U S NAVY RESPONSE TO U S EPA REGION III ADDITIONAL COMMENTS TO DRAFT  
SAMPLING AND ANALYSIS PLAN SITE 7 EXPANDED REMEDIAL INVESTIGATION NWS  
YORKTOWN VA  
5/14/2012  
CH2M HILL

Subject: Response to Additional Comments received April 20, 2012 on the Draft Sampling and Analysis Plan, Site 7 Expanded Remedial Investigation, NWS Yorktown, Yorktown, Virginia

Figure 1  
 Site 7 Proposed Soil Sample Locations  
 Naval Weapons Station Yorktown  
 Yorktown, Virginia

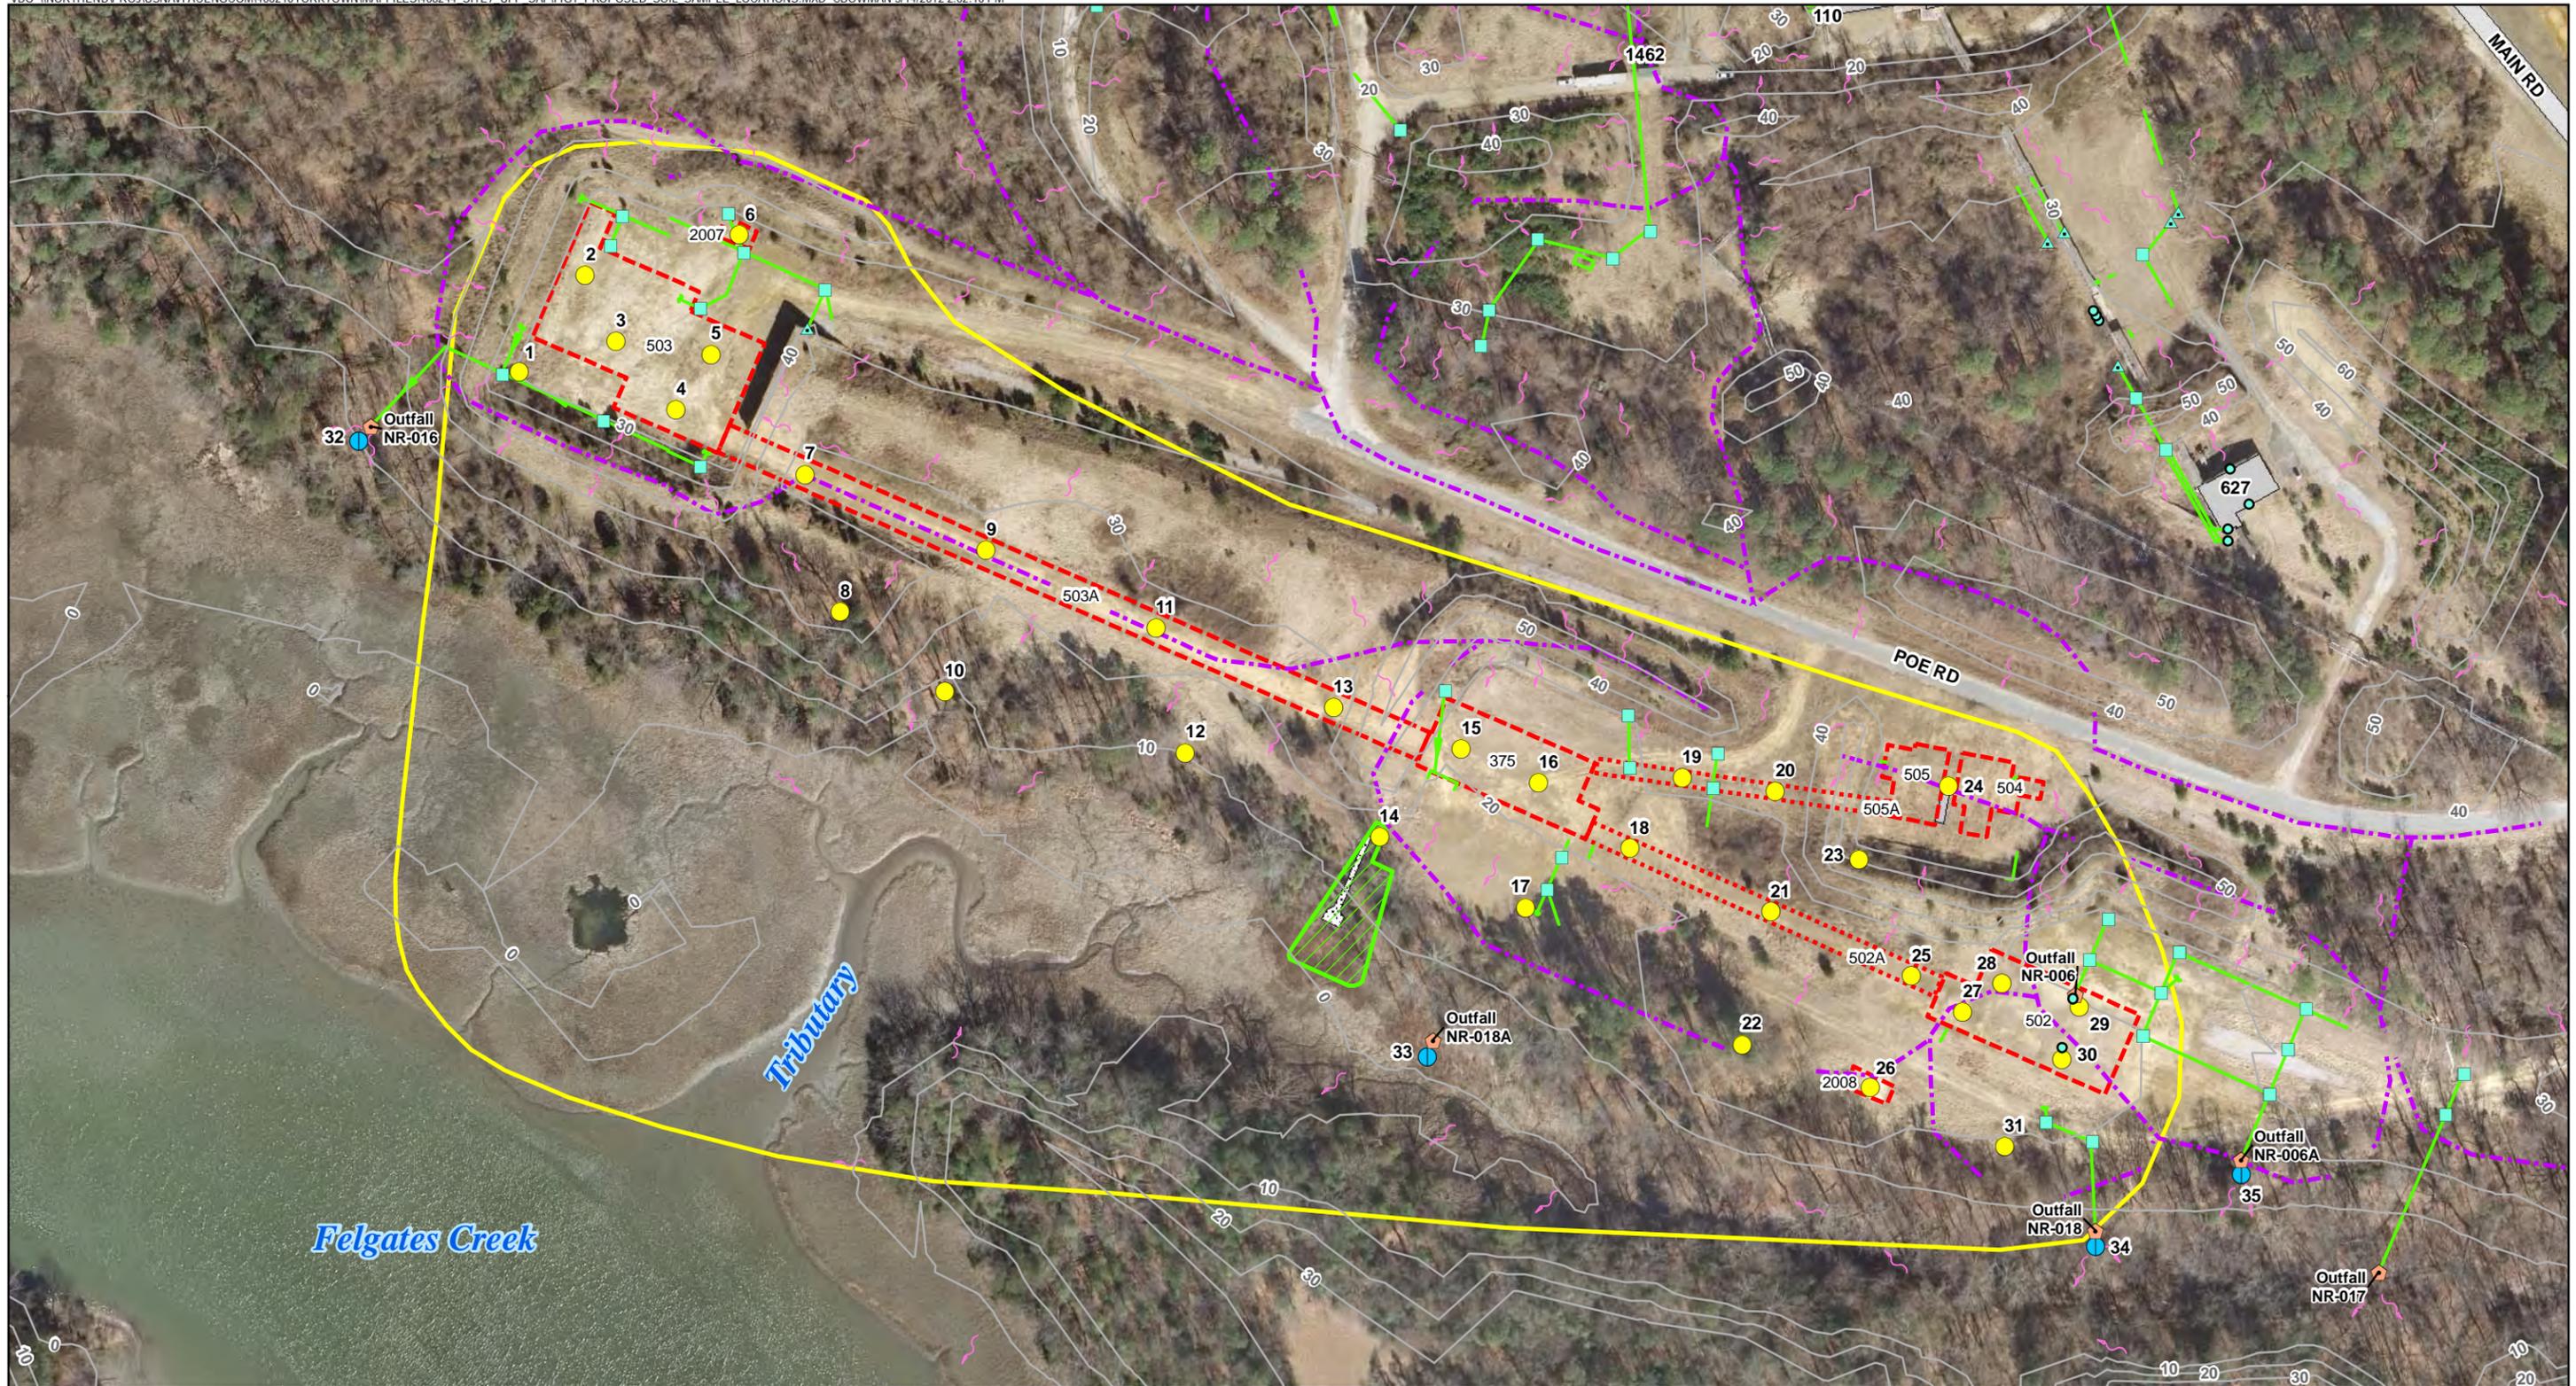
The information from these three documents suggests the selection of sample locations shown on Figure 1 in the responses to comments is too limited.

2. The response to comment 1 refers to Figure 1 which shows the proposed soil sampling locations along with other features of this site. A review of this figure has raised the following concerns:

- Specific reasons for selecting the sample locations need to be included in the text (the information contained in Table 1 is not sufficient).
  - Sample locations 1, 6, 10, 23, and 24 appear to be some distance away from any of the former buildings or conveyor belts. Specific reasons are needed to support the locations of these samples.

- Sample location 9 is in the upgradient end of the removed soil area, which according to Figure 1, extended into the wetlands of a tributary to Felgates Creek. Again, specific reasons are needed to support this one discrete sample location.

- Because the removal area (a part of the area known as Site 7 in the 1998 ROD) was only shown to be protective of human health (e.g., commercial/industrial), this area needs to be appropriately sampled to demonstrate that it currently is, or is not, sufficiently protective of ecological receptors.

- Areas draining to all drop inlet structures (approximately 26-see Figure 1) need to be sampled.
  - Areas downgradient of all outfall structures (approximately 6-see Figure 1) need to be sampled.

- The report will need to document that all existing drop inlet structures are tied into an identified outlet structure.

Generally, the limited supporting information in this expanded RI SAP about discrete sample locations leads to uncertainty about the number and location of samples. In reference to soil samples, the upland portion of this site, within the drainage boundaries, is approximately 13 acres. The placement of 25 discrete soil samples in 13 acres is not reasonable for quantifying contaminant concentrations or for assessing ecological risk. USEPA believes that composite sampling, as recommended in the December 15, 2011 comment letter is a better approach at this site.

6. Response to comment 12: The single sample location in the upgradient portion of the removal area is not sufficient to determine if current concentrations in soil pose a potential risk to ecological receptors. Based on a review of Figure 1 in the responses to comments, the removal area would need more than one sample in order to make this determination. Also, the variability that can exist between discrete soil samples does not support the use of a single sample to characterize contaminant concentrations in the removal area. Again, MIS may be appropriate and needs to be adequately investigated.

- *The specific reasoning for the proposed sampling locations has been updated and is provided in the attached table. This table contains information identifying the most likely potential release points and contaminant accumulation areas based on site history and surface topography. The information in this table will be included within the text of the UFP-SAP.*
- *The sample locations have been revised. Upgradient soil sample locations have been removed. Please see the response to Comment 1 and Figure 1 (attached).*

- *Please see the attached table for the specific reasoning for placement of the referenced removed soil area sample (current sample number 14 on Figure 1). The single discrete sample location at the upgradient edge of the drainage area will evaluate surface runoff entering into the drainage area.*

- *The proposed sampling approach will evaluate the most likely release locations and locations of contaminant accumulation based on surface topography. The Navy also agrees to collect sediment samples from each outfall location as shown on Figure 1 (attached). A field visit has confirmed that the majority of drop inlets identified on the figure (from the base Stormwater Pollution Prevention Plan [SWPPP]) were removed or buried during building demolition and are, therefore, inaccessible. Sampling of each drop inlet location is not warranted, as each potential source area and each outfall will be evaluated.*

- *The Navy agrees to collect a sediment sample from each downgradient outfall location as shown on Figure 1 (attached) and summarized on the attached table. The outfall identified as "Outfall NR-006" is no longer evident and received runoff from areas upgradient of the building activities. However, a soil sample has been placed in the vicinity of this outfall location (sample 29; attached Figure 1). A sample will not be collected from "Outfall NR-017", as there are no drainage features that connect Site 7 to this drainage feature.*

- *Drop inlets were either removed or buried during the demolition activities and are no longer accessible. The locations of the drop inlets (and associated piping) and outfalls provided on the figure were obtained from the Base SWPPP. All features that discharge to outfalls will be assessed through the sampling of the outfall locations. Surface runoff from potential source areas via drainage ditches and/or overland flow will be assessed through the soil samples proposed in the attached table.*

*The 31 proposed soil sample locations shown in Figure 1 and detailed in the attached table are adequate to evaluate potential releases and assess potential site-related risks. The collection of the proposed discrete samples will provide sufficient data to conduct a quantitative risk assessment without the need for composite samples.*

*Response: Please see bullets 3 and 4 in the response to Comment 2. Ecological risks were considered and previously evaluated as documented in the 1998 ROD. Additionally, both the 2002 and 2007 Five-Year Reviews (Baker, 2002 and CH2M HILL, 2007, respectively) document that the remedy for soil and sediment is protective of human health and the environment. The single discrete sample location at the upgradient edge of the drainage area (sample 14 on the attached Figure 1) will evaluate surface runoff entering into the drainage area.*
